**Re: Kimber Residence  
0 Pinecrest Parkway**

This letter is to request that the Steep Slopes and View Preservation Review be continued at the February 16, 2020 meeting of the Planning Board.

- A. An alternative design for the house consisting of three sheet of drawings prepared by Gotham Design & Community Development Ltd. under the review of Laura Wakefield, R.A., dated as submitted January 30, 2020, for the Planning Board.
- B. A Narrative documenting the fact that the subject property has steep slopes and making a request for a Special Hardship Exception from the Planning Board to permit the limits stipulated in the Code under Section 240-5.A. to be exceeded.

**SP-2**

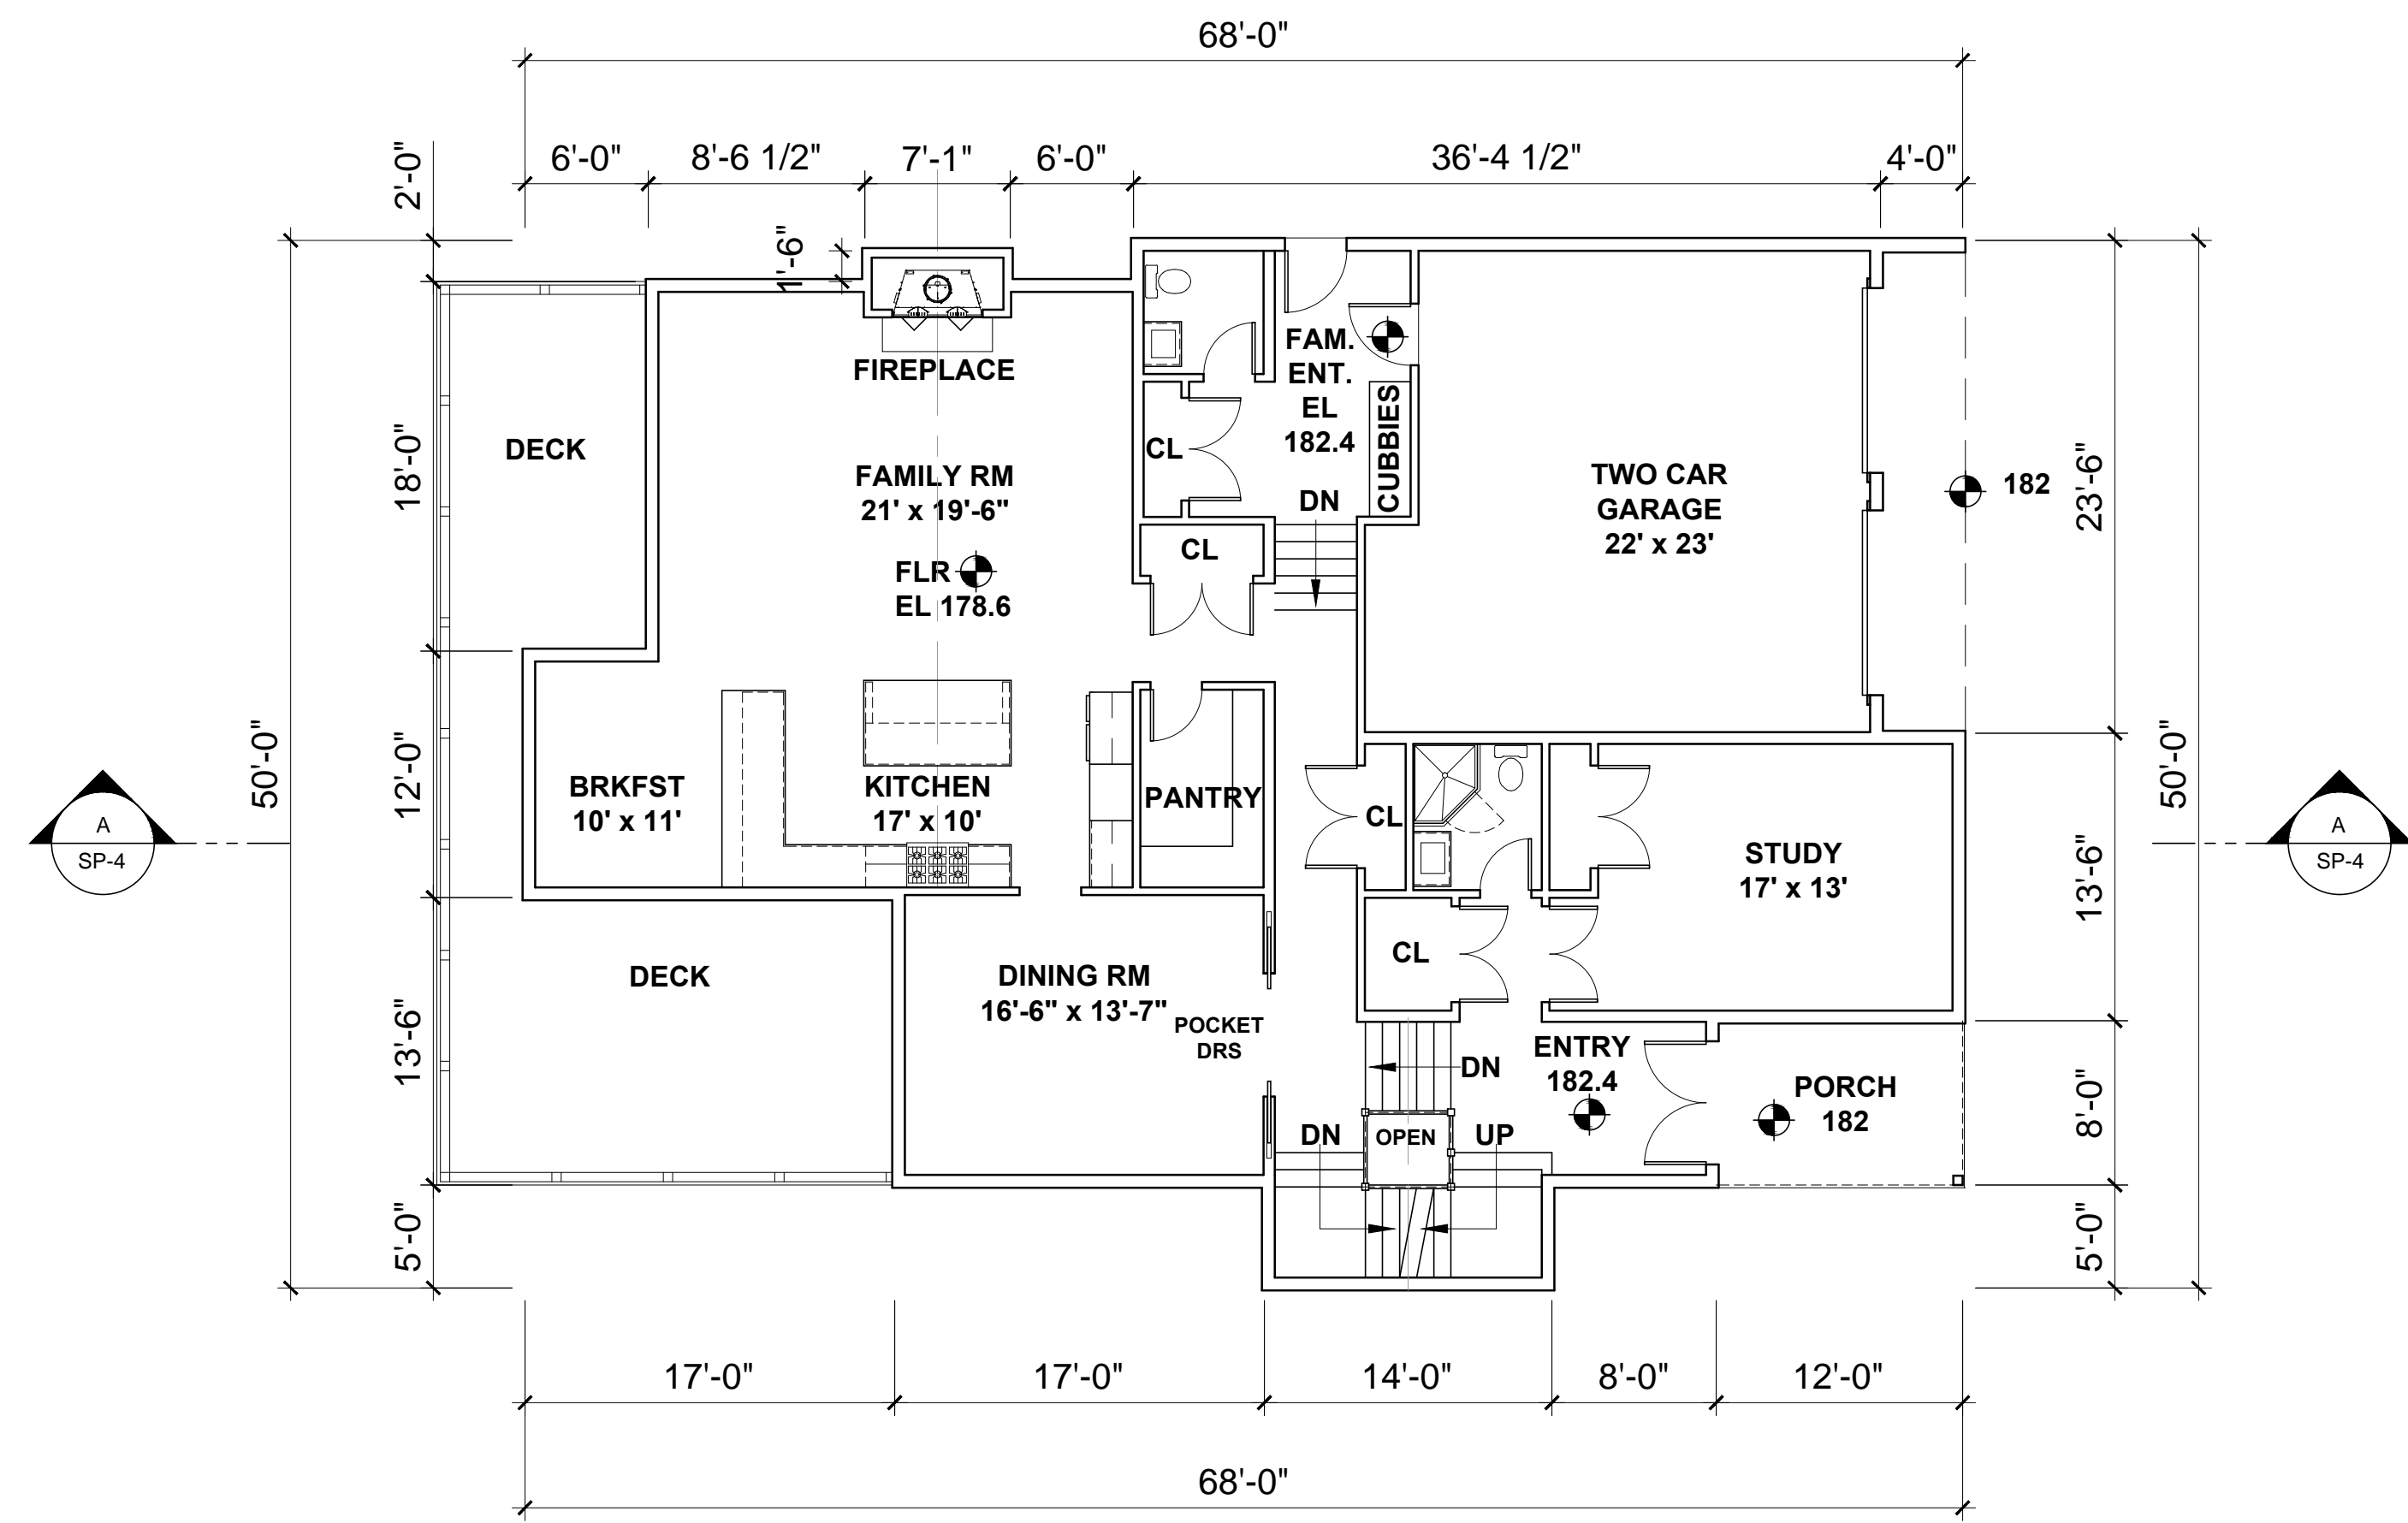
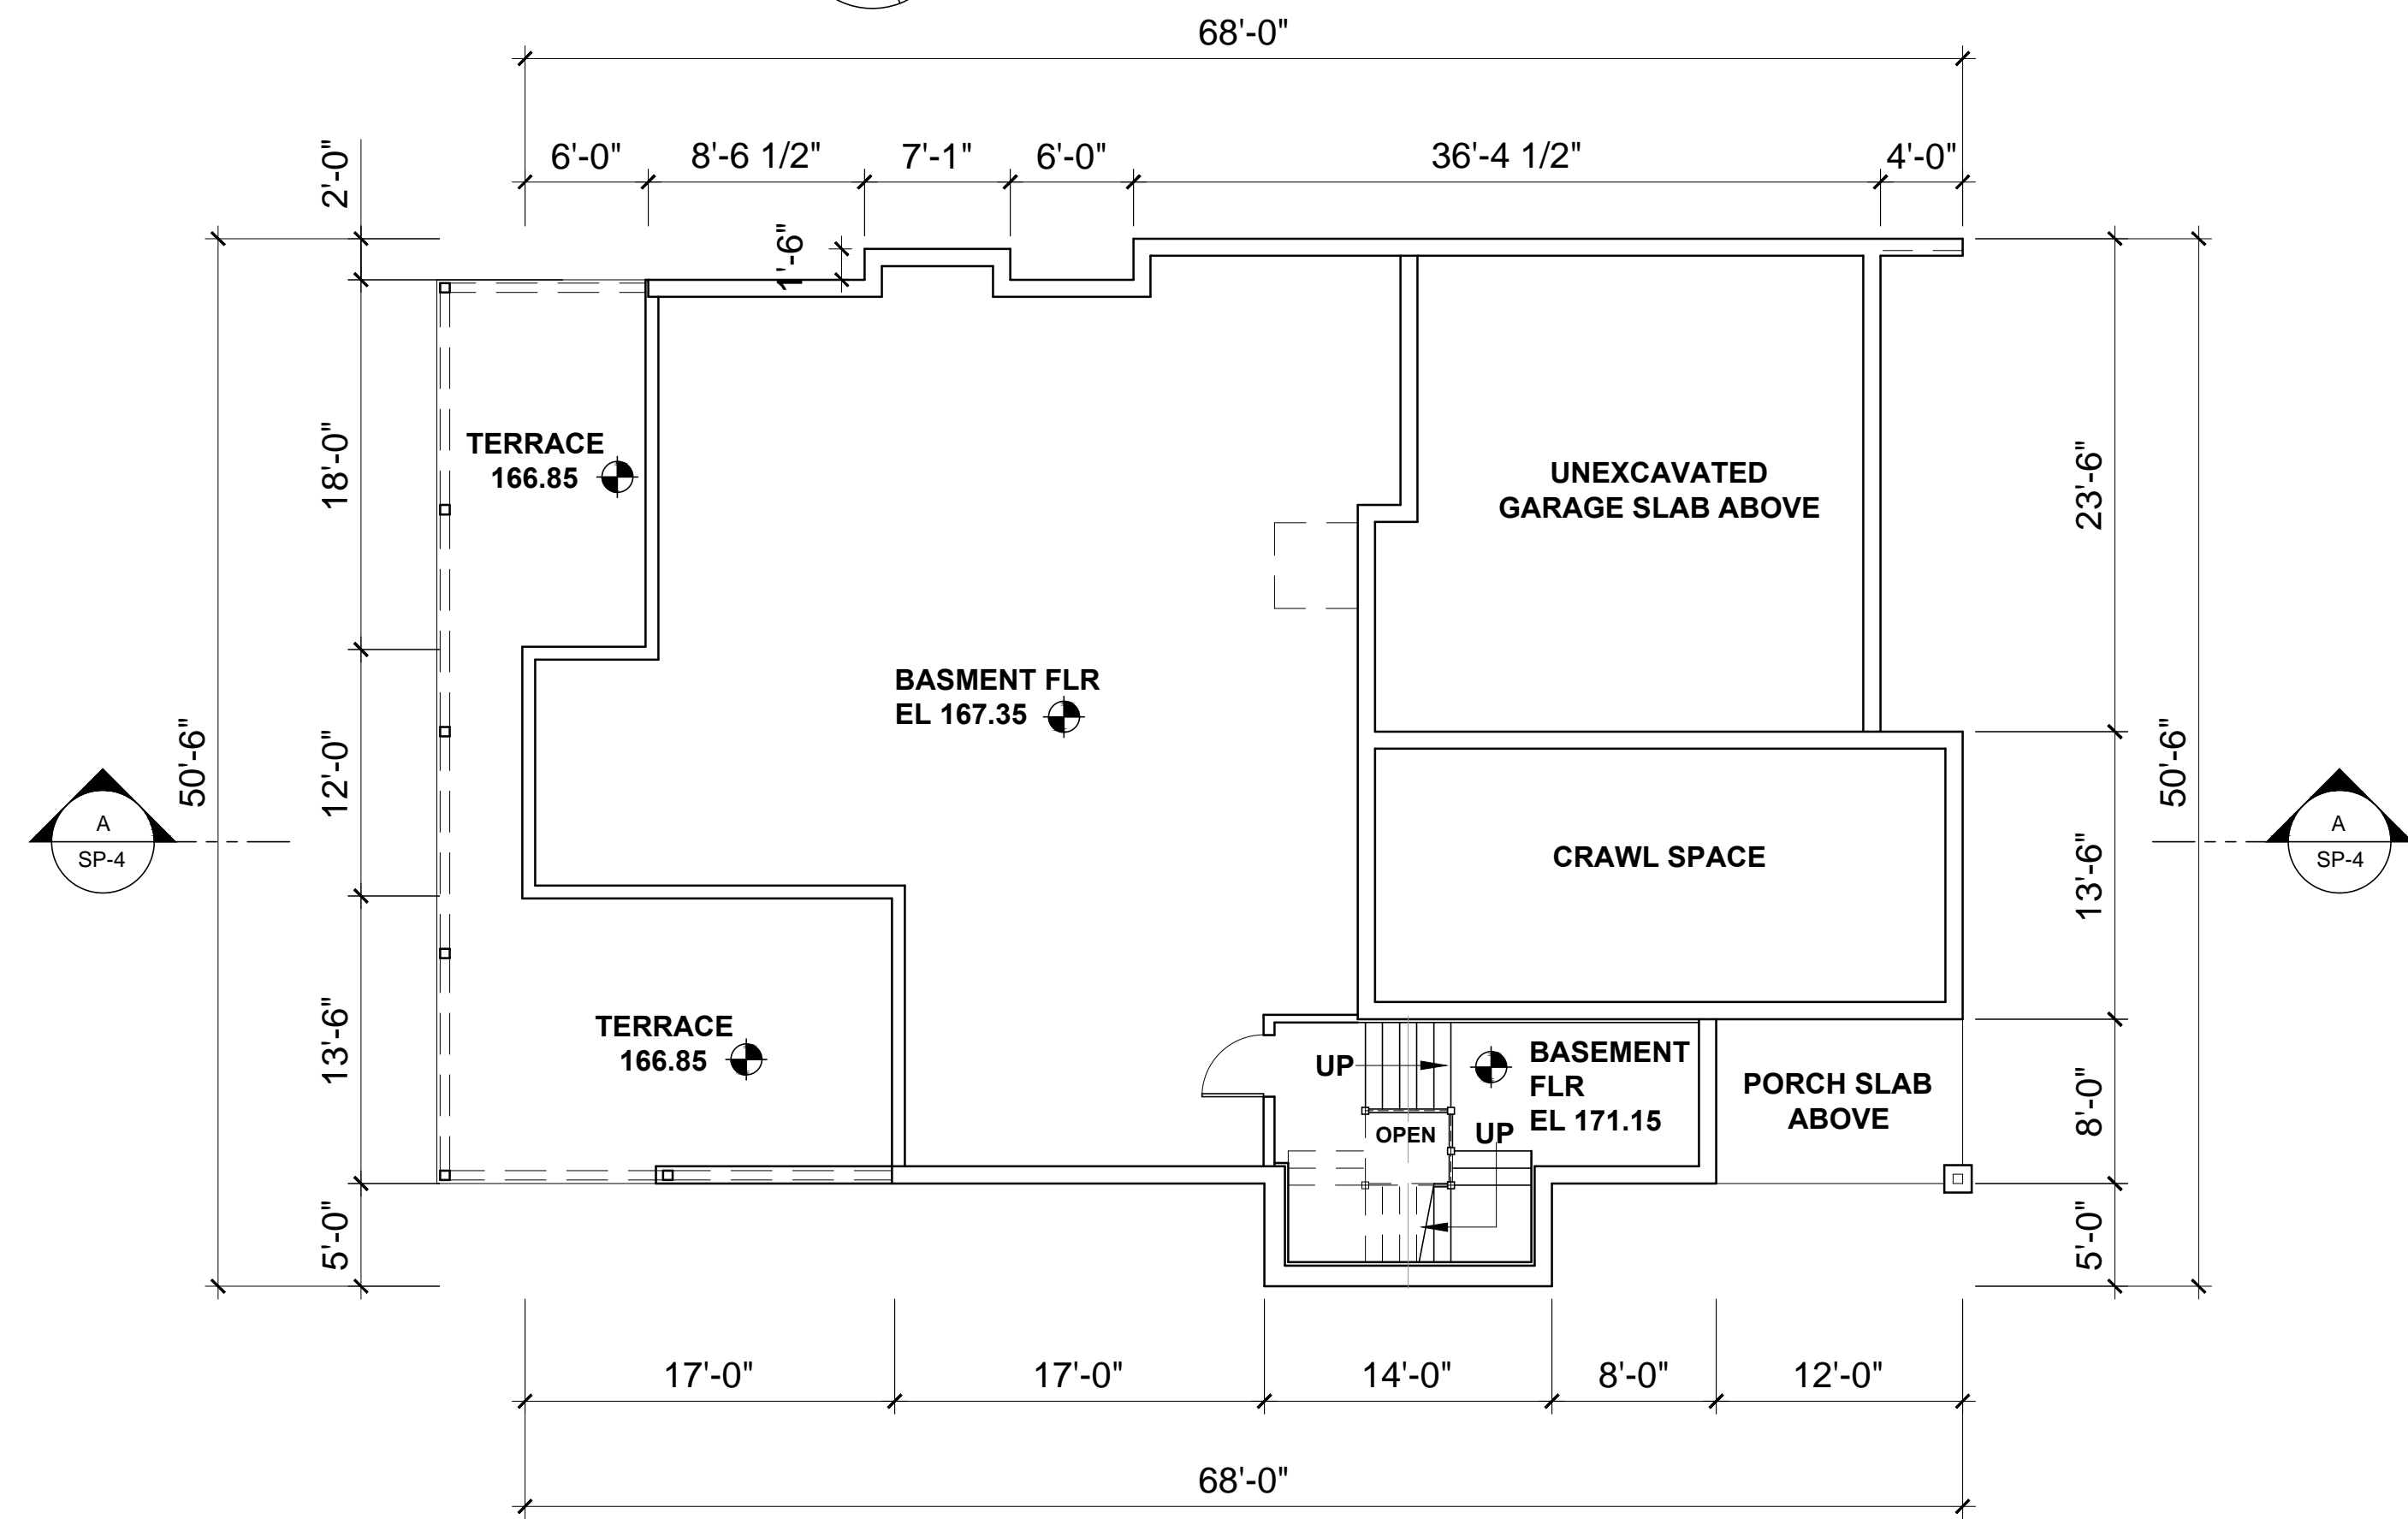
6. The alternative design has a split level such that the west half of the house has a first floor elevation of 178.6 and the east half of the house has a first floor height of 182.4. Similarly, the west half of the house has a second floor height of 189.93 and the east half of the house has a second floor height of 193.73.

7. Both the original design and the alternative design are configured such that the second floor ends significantly short of the extent of the first floor to the west. This is to reduce the mass of the house as perceived from the Aqueduct.
